**From:** [jim.mattison.me](mailto:jim.mattison.me)  
**To:** [Molly McGuire](#)  
**Cc:** [susan.mattison.me](mailto:susan.mattison.me)  
**Subject:** Permit 2207-019 SUB2 Mattison comment ltr  
**Date:** Saturday, March 11, 2023 9:34:16 AM  
**Attachments:** [2207-019 SUB2 Mattison ltr.pdf](#)

Re: Permit No. 2207-019 SUB2 - Strand Residence - 6950 SE Maker St. - Additional Input and Feedback

Ca. 1955 view of south (front) and west (rear yard) elevations of 6950 SE Maker Street depicting extensive fill material sloping to foreground prior to rockery placement. Note the lack of native vegetation. Present day Maker Street is in lower right of photo.

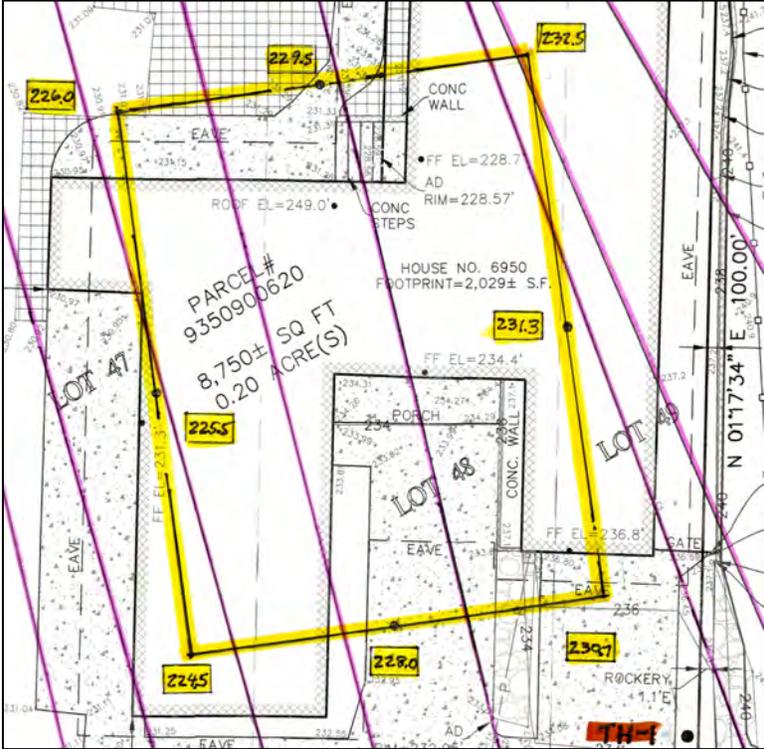
We object to the existing grade for the 6950 site being designated as "the surveyed grade prior to start of this proposed project (5/27/2021)" as stated in the applicant's Comment Response in reference to Terrane survey sheet 1 of 1.

This site was significantly "altered" prior to development of the existing home with extensive placement of fill materials which were retained with tall rockeries. This is well documented in the October 2022 public comments and the geotechnical engineer's initial report.
